# Memo

**File No:** DVP10-0086

**At:** 1344 Mountainview St.

**Purpose:** To vary the minimum flanking southern side yard setback to an accessory building from 4.5m required to 1.0m proposed.

SITE PLAN

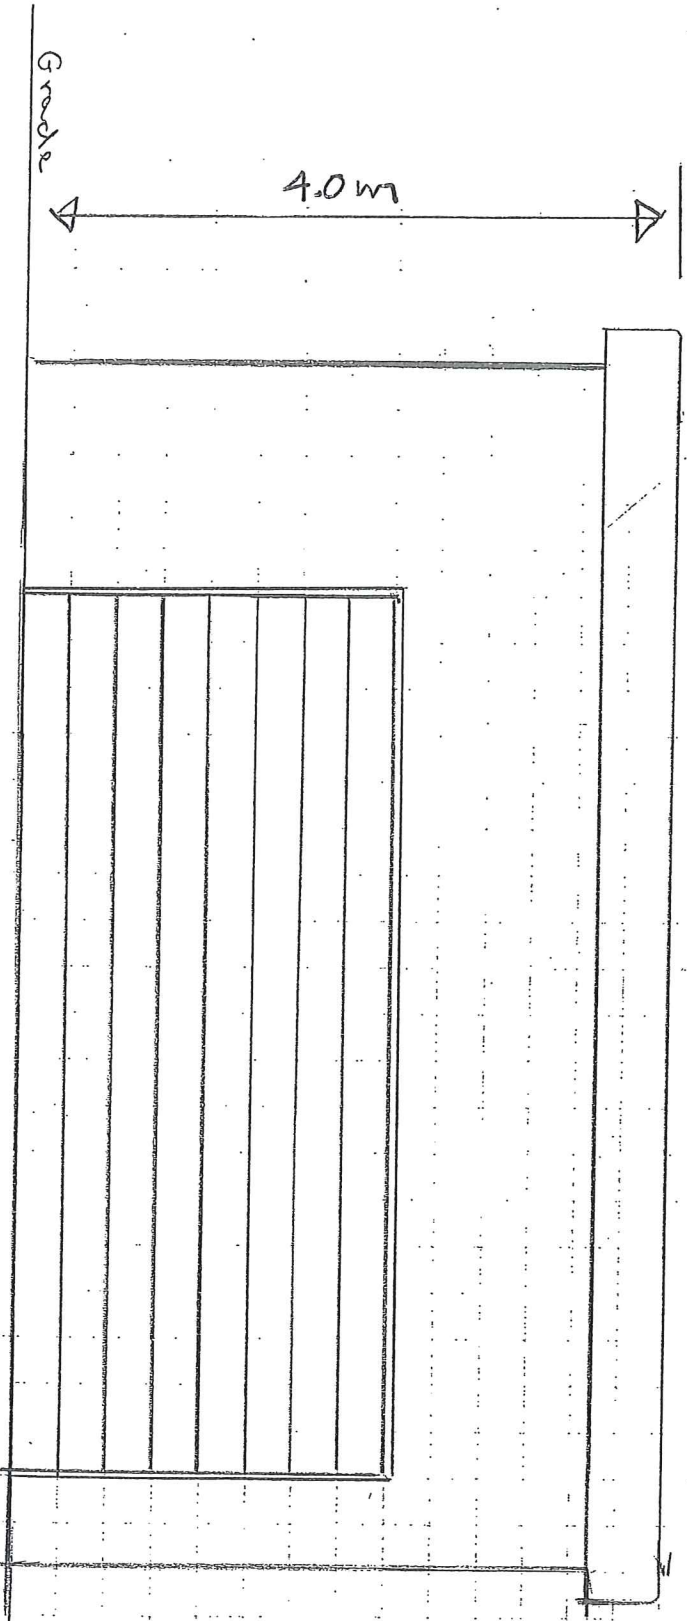
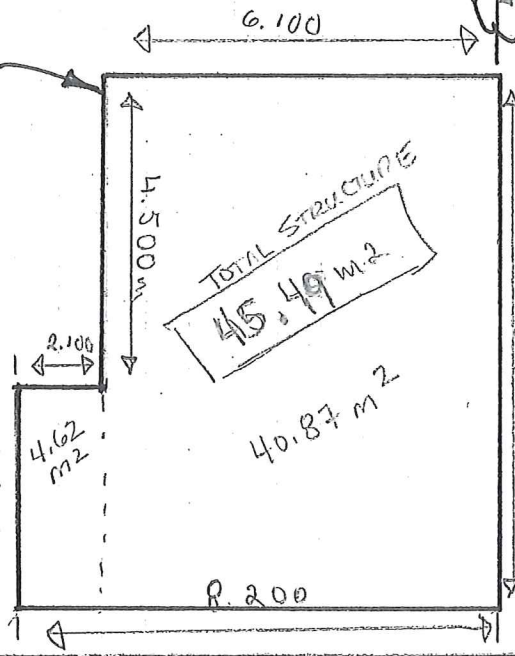
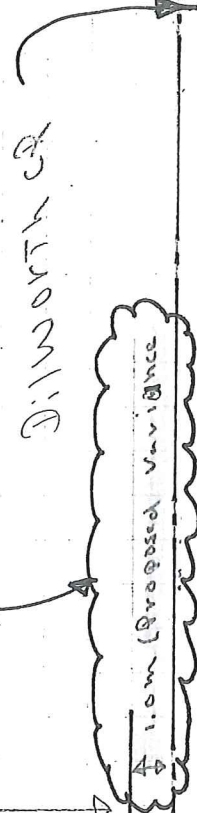
To vary the minimum flanking southern sideyard setback from 4.5m required to 1.0m proposed, as shown on Schedule "A".

① To vary minimum flanking sideyard setback from 4.5m required to 1.0m proposed.

EAST ELEV  
(MIRROR IMAGE)

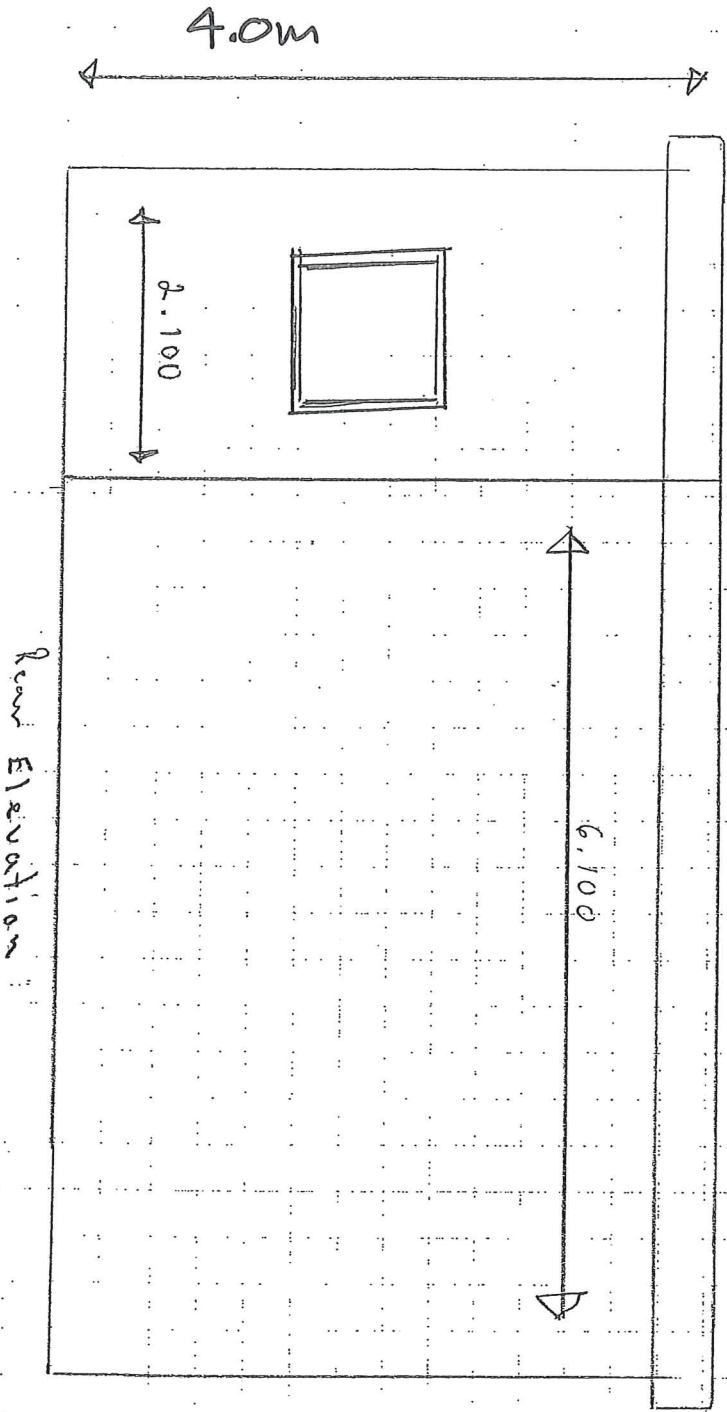
1) This building structure appears to be over the 4.5 meter height allowance. The building code requires 150mm min from top of foundation to finished grade and a detail of the continuous perimeter parapet c/w flashing details are required on the drawings submitted to define height.

*\* The applicant has confirmed that the building will only be 4.0m high.*
